BLUE BIRD

Alternator Drive Belt

MODELS AFFECTED: 2008 BBCV Visions w/CAT C7-07 Engines

S07MH

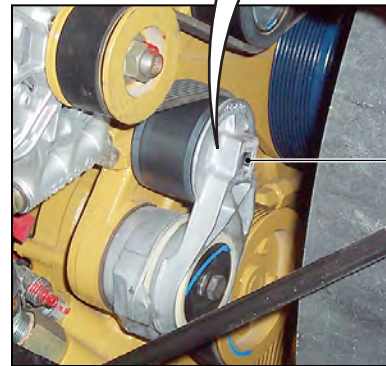
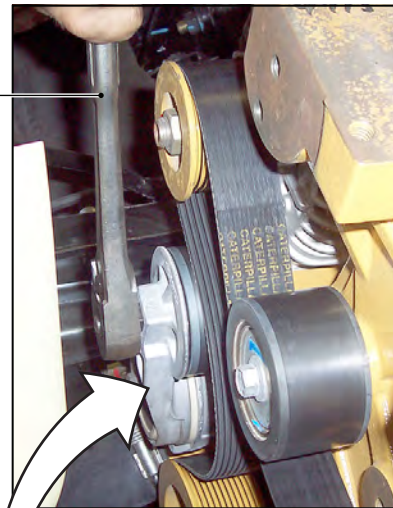
The original alternator drive belt is not the proper length for the application. Under high temperature conditions, the engine may overheat due to insufficient tension on the engine fan pulley. The original alternator drive belt must be removed and replaced with the correct alternator belt according to the instructions provided in Service Bulletin S07MH. Copy attached.

The alternator drive belt on the CAT C7-07 engine is not the correct length.

Replace the alternator drive belt with a new drive belt provided (Blue Bird P/N 0122527).

- 1** Park vehicle on a level surface, apply parking brake, turn engine off and remove ignition key.
- 2** Locate the alternator drive belt idler pulley. Using a 1/2 inch drive pull handle, insert it into the square socket of the idler pulley arm. Apply force upward in a counter-clockwise direction to release tension from the belt and slide the belt off the pulley. Slowly release the applied pressure from lower idler pulley.

- 3** Working the belt around the other engine components in a circular motion, remove the belt and discard.
- 4** Install the new belt (Blue Bird P/N 0122527), slipping it over the other engine components and onto their pulleys.

- 5** Insert the 1/2 inch drive pull handle into the square socket of the idler pulley arm. Apply force upward in a counter-clockwise direction and slip the belt into place at the idler pulley. Ensure the belt is correctly aligned on all pulleys before releasing pressure from the idler pulley.
